ATTACHMENT 2

PROPOSED TECHNICAL SPECIFICATION CHANGES

FOR DRESDEN 3

FIGURE 2.1-3
(SCHEMATIC)

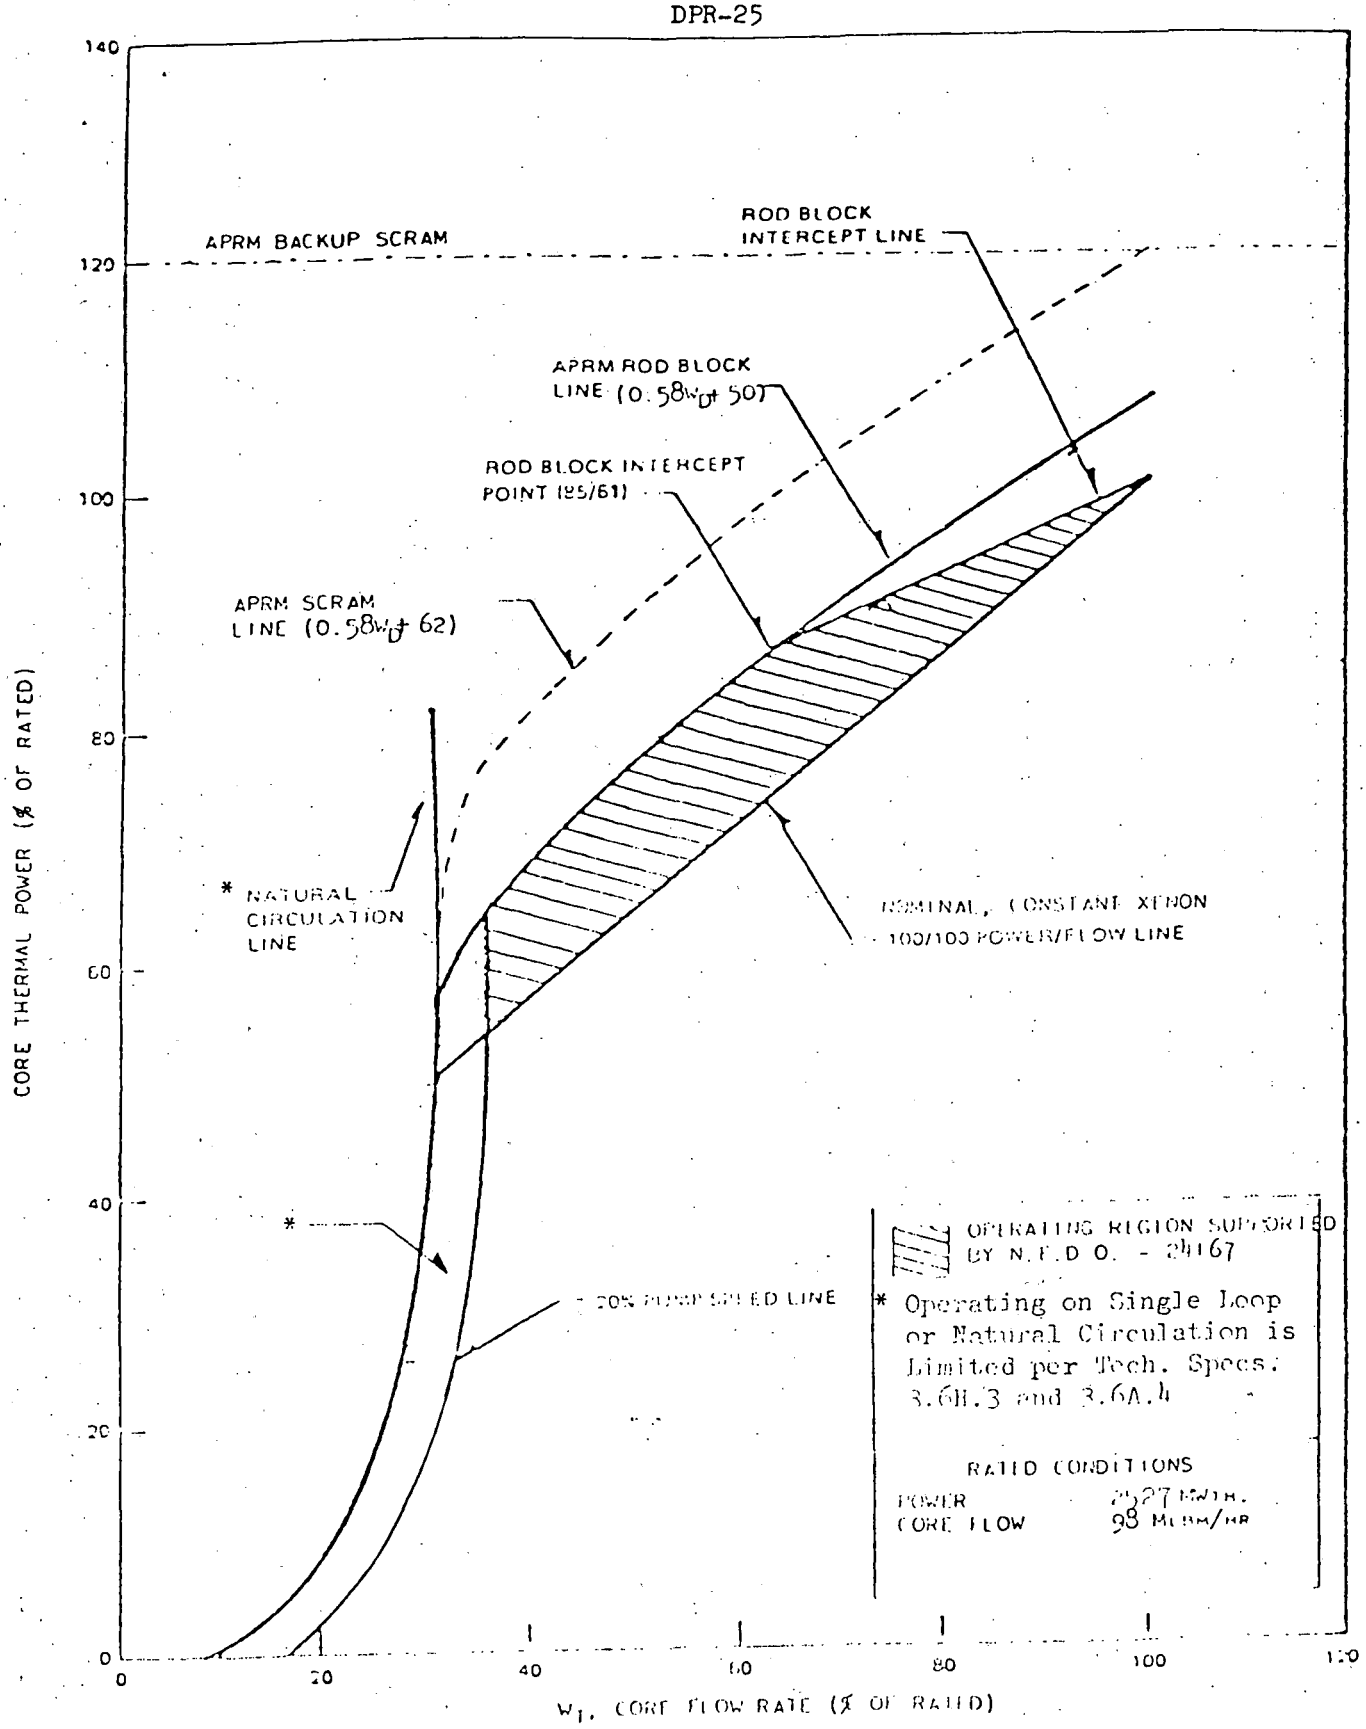
$$S \leq \left[0.58W_D + 62\right]\left[\frac{LTPF}{TPF}\right]$$

with a maximum set point of 120% for core flow equal to 98 x 10^6 lb/hr and greater.

where:

S = setting in per cent of rated power

W_D = percent of drive flow required to produce a rated core flow of 98 Mlb/hr.

TPF = LTPF unless the combination of power and peak LHGR is above the curve in Figure 2.1-2 at which point the actual peaking factor value shall be used.

LTPF = 3.05 (7X7 fuel assemblies)

3.01 (8X8 fuel assemblies)

$$S \leq \left[0.58W_D + 50\right]\left[\frac{LTPF}{TPF}\right]$$

The definitions used above for the APRM scram trip apply.
